F.I.A. Recognition No. 1605
Group II Touring Car

Manufacturer FORD MOTOR COMPANY LIMITED Cylinder-capacity 1840,8 ~~1601~~ cm.³ 97.55 in.³
Serial No. of chassis/body BB49KL 11059 Model ESCORT RS 1600
Serial No. of engine HE 1001 Manufacturer FORD
Recognition is valid from 1st October 1970 List 1970/10
The manufacturing of the model described in this recognition form started on 11 January 1970
and the minimum production of 1000 identical cars, in accordance with the specifications of
this form was reached on 1st September 1970.

Amendment to Form of Recognition

Photo 1

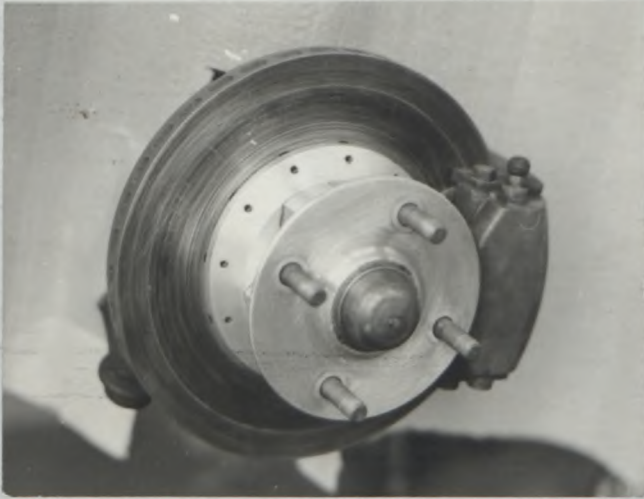
No.	Reference No.
	<p>Ventilated brake disc front Part No 90 51671/2 Outside dia: 11,67 ins 29,65 cm</p> <p>Photo No 1</p> <p>Alternative supplier Brakes of different type and dimensions which include larger hubs, stub-axles and wheel hubs</p> <p>ventilated brake disc front Part No 9050 981 A/B outside dia: 11,97 ins 30,4 cm</p> <p>Photo No 2</p> <p>light metal brake caliper Part No 9050 987 A/B brake area per wheel: 9,0 sq ins 58,06 sq cms No of pads per brake: 2</p> <p>Photo No 3</p>

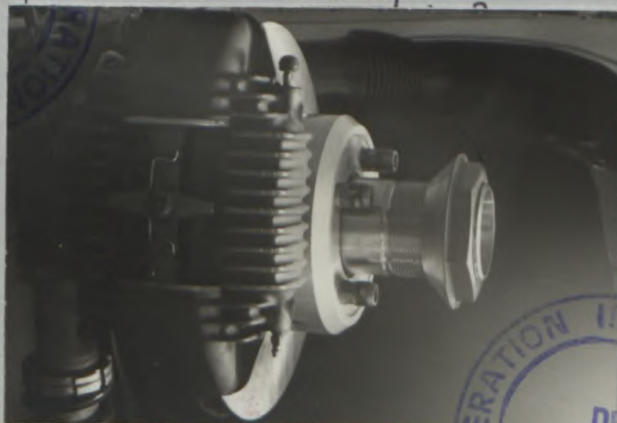
No. | Reference No.
 Group 2 variant
 Alternative brakes of different type and dimensions including different hubs, half-shafts and bearings with housings.

100 | Front disc see amendment 15/14V
 Light metal front brake caliper Part No. 9050 9889A/B
 105 | 5100mm² 7.9 ins.
 Photo 1

100 | 292mm 11.49 ins.
 Light metal rear brake caliper
 105 | 3500mm² 5.42 sq.
 Photo 2.

G76-3

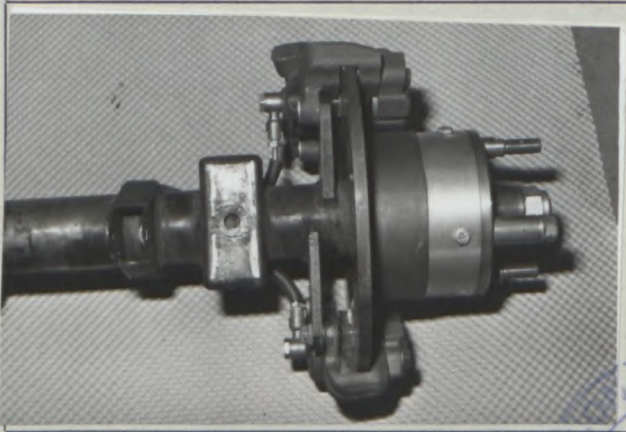
No.	Reference No.					
	Alternative brakes rear including HD hubs					See photo G76/3
	Discs					
No. 100	254	267	244	267	292 mm	
No. 101	9.6	11	20	21	21 mm	
	Type	Solid	Solid	Vented	Vented	Vented
	Rear calipers, incorporating mechanical handbrake mechanism					
	1. Supplier ATE					See photo G76/4
	2. Supplier AP					See photo G76/5
	Rear calipers without handbrake mechanism, but including supplementary mechanical handbrake mechanism.					
	1. Supplier Girling					See photo G76/6
	2. Supplier ATE					See photo G76/7
	Supplementary mechanical handbrake mechanism					See photo G76/8

G76-1

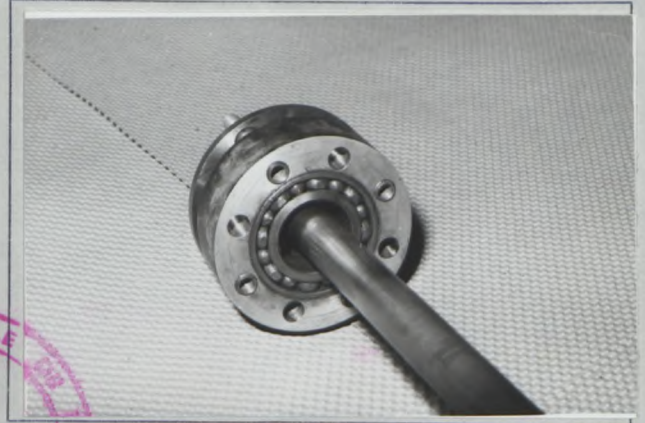
No.	Reference No.
	Reinforced front suspension system incorporating: Altered roll bar Reinforced roll bar mounting Reinforced chassis member Reinforced top mount bar See photos D76/1
	[REDACTED]
	[REDACTED]
	Reinforced suspension elements hub and bearing assembly See photos G76/1
	HD rear drum brake assembly
95	328 mm
96	35.6 and 31.5 mm
97	14 mm
98	2
	See photos G76/2
	Reinforced pedal box assembly for dual circuit brake system See photo X76

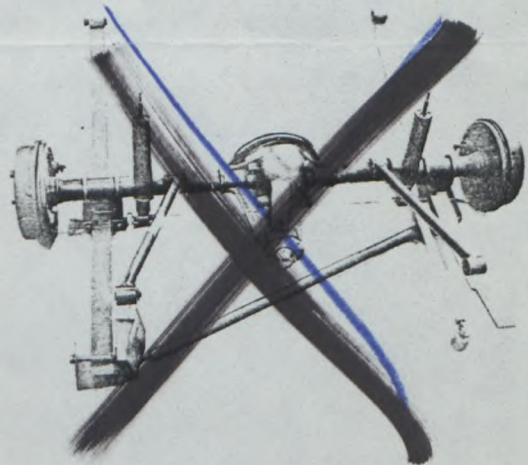
True rear brake 10" x 2 1/2"

95	I.D.	254 mm
96	Length	2 x 240 mm
97	Width	55 mm
98	No.	2

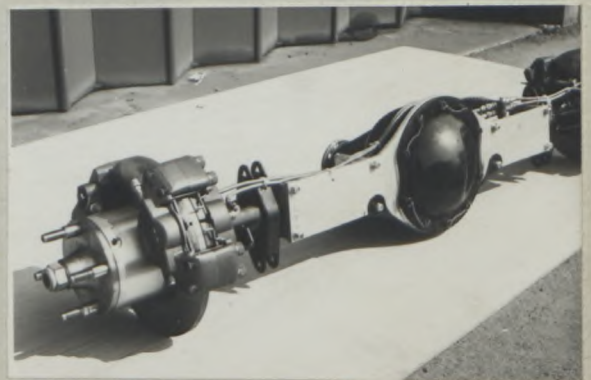
Alternative supplementary hydraulic handbrake (additional to
 mechanically activated system). See photo G77/1 and G77/4.

Alternative rear brake caliper incorporating mechanical handbrake
 mechanism. See photo G77/3.

Reinforced shockabsorber mounting bracket, see photo E77/1.

Reinforced heavy duty rear axle, see photo G77/4
 Reinforced suspension top brace - see photo G77/2
